# Revised LS Plan (4.25.25) 28229 Manzella Dr (Markup Summary).pdf Markup Summary

**NEW OFFICE/ STORAGE**  
38299 MANZELLA DRIVE  
SLIDELL, LOUISIANA 70461

**SITE PLAN- NEW WORK**

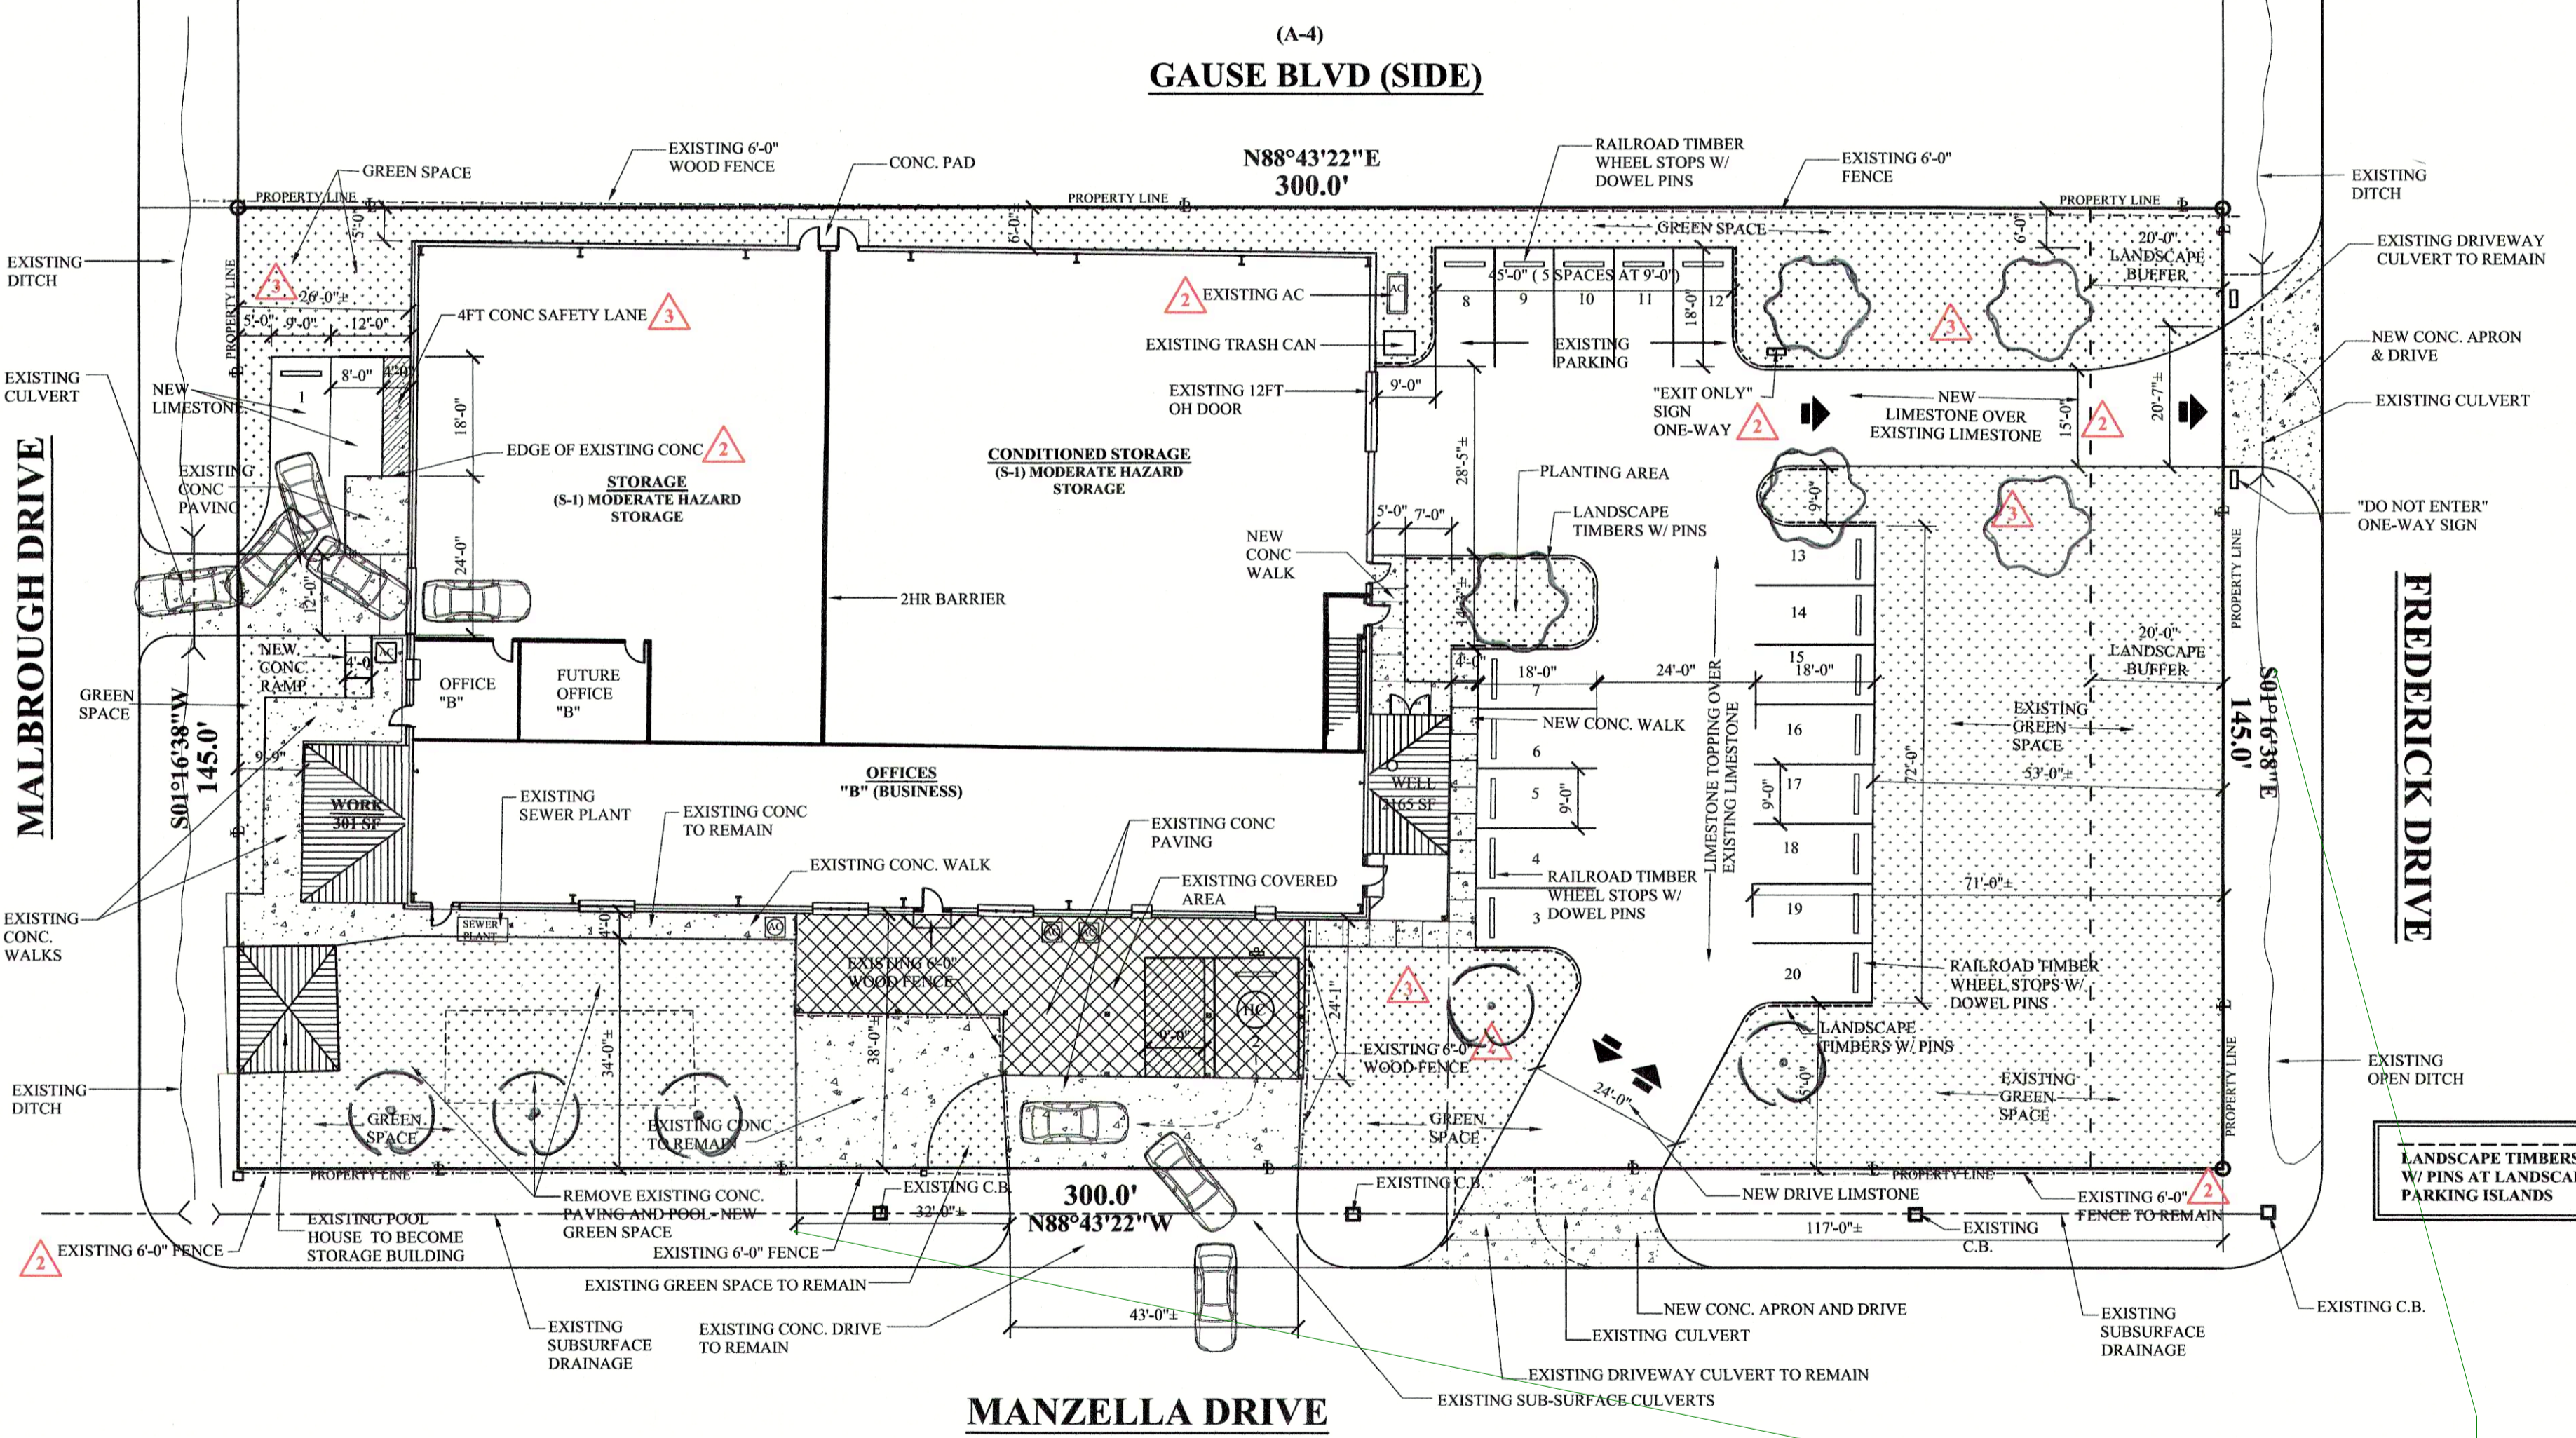
Per Sec 600 3.4 C (1) Plans must be created and stamped by licensed landscape architect. Plan must include caliper, height and species of all existing and proposed landscape material (trees, shrubs, grass, mulched area etc.) as per this section of code.

Code requires an irrigation plan. For existing site, as per Ross Liner, Planning Administrator- a note describing method of watering of new material will suffice. Add note as shown:

Add parking calculation to Landscape Plan per Sec 600 5.1 Parking Requirements

Please add Certification Stamp or similar to plan

Note on Plan: Alt/ Compliance: Some existing trees in r.o.w. have been approved to supplement the required buffers. Protect all trees in STP ROW during and after construction, typical.

Please Label this Plan "Alternative Compliance Landscape Plan" note: Some items which do not meet current code have been approved per Ross Liner, Director Planning & Development)

Irrigation Note: New trees, shrubs and living ground cover will be maintained by owner/applicant using sprinkler, tree bags and hose watering in lieu of an automatic irrigation system. Any landscape material which does not survive will be replaced within 60 days per ordinance."
